BUREAU OF LAND MANAGEMENT

January 4, 2005

Re: Minor Modification of Resource Recovery and Protection Plan (R2P2), 2nd Left off 3rd North Mains Longwall Block, Blind Canyon Seam, Deer Creek Mine.

MINING PLAN APPROVED
BUREAU OF LAND MANAGEMENT
Recommended By: *[Signature]*
Mining Engineer (Date) 29 Dec. 2004
Approved By: *[Signature]*
Manager (Date) 01/03/2005

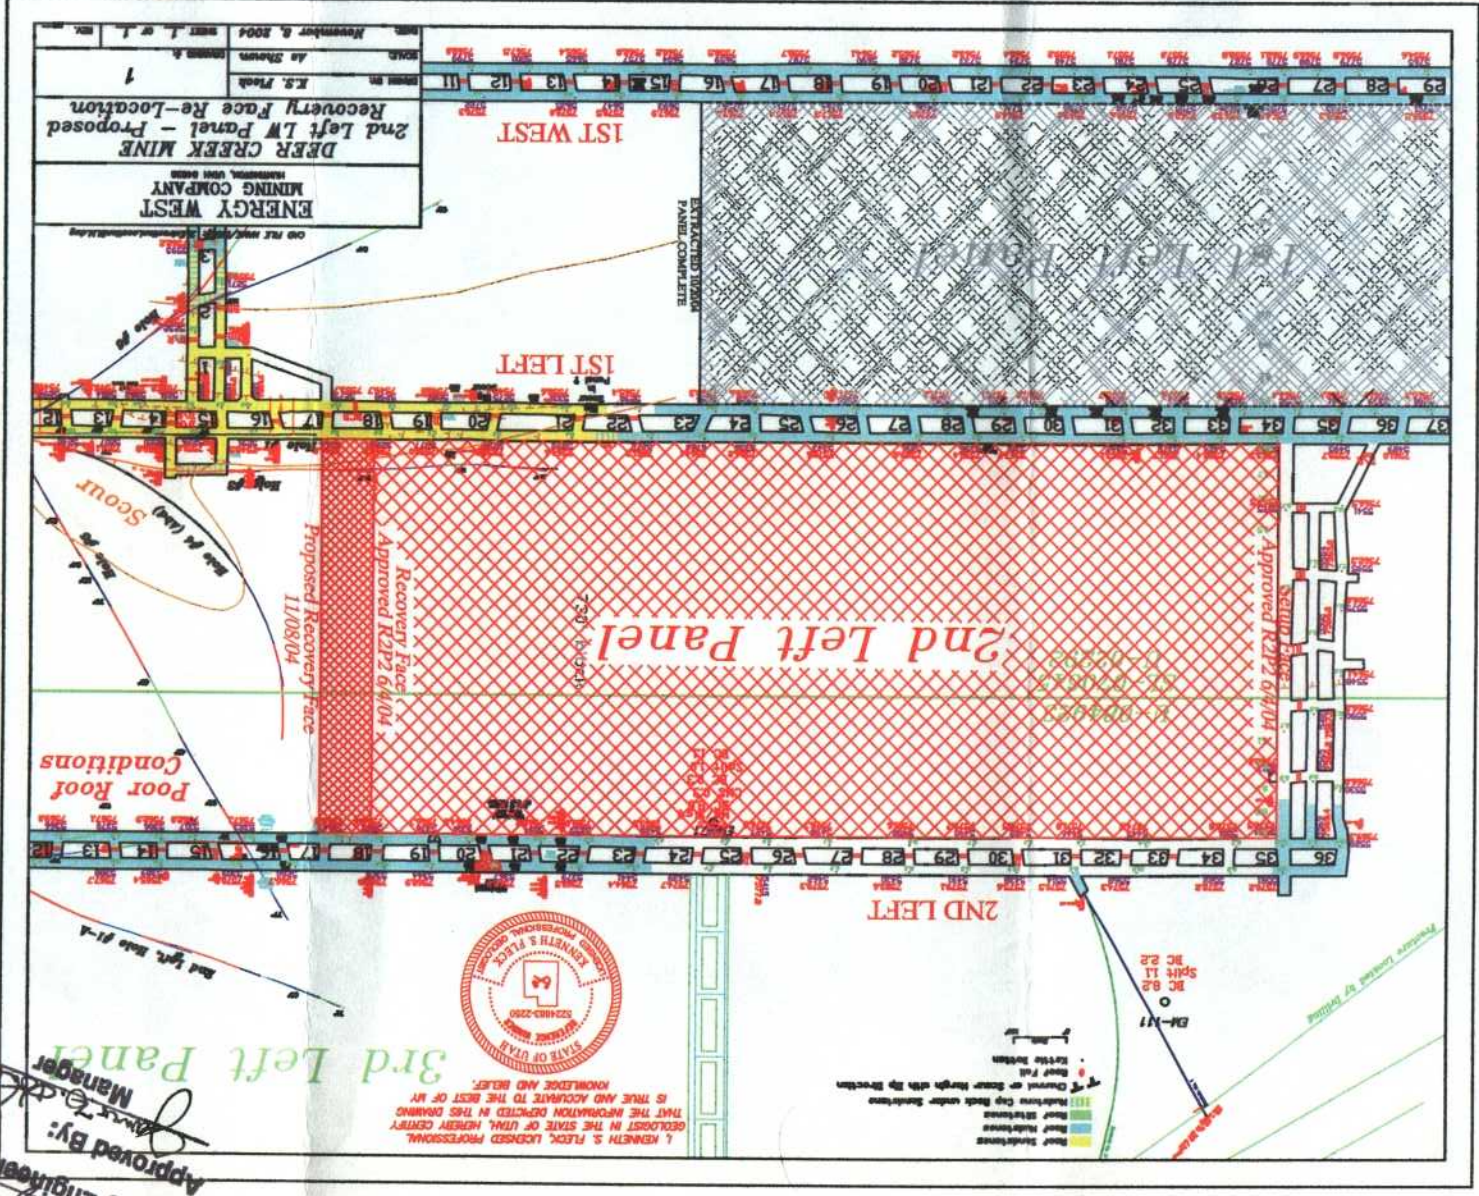
Interwest proposes to mine an additional approximately 100 feet by retreating the longwall one additional crosscut (from crosscut 18 to crosscut 17). The company projects this will result in the recovery of an additional 27,000 tons and BLM has calculated the added tonnage could be 10% to 20% less.

BLM inspected the area most recently on 2 November 2004, confirming the conditions shown. Although unlikely, it might be possible to recover an additional 100 feet of longwall coal and remove the longwall at crosscut 16. The company will keep BLM informed of the geologic conditions as the longwall reaches the point of starting the steps necessary to remove the longwall. BLM will then confer with the company to determine if additional coal can be recovered. A timely decision will be provided by BLM based on the information presented by the company.

The modification to the R2P2, as depicted on Drawing #1 dated 8 November 2004 (CAD FILE NAME/DISK#: Deer Creek Mine 2nd Left LW Panel - Proposed Recovery Face Re-Location), is approved, pending the final location of the longwall recovery room. A copy of the approved mine map is enclosed. If you have any questions, please contact Stephen Falk at the Price Field Office (435) 636-3605 or Jeff McKenzie of my staff at (801) 539-4038.
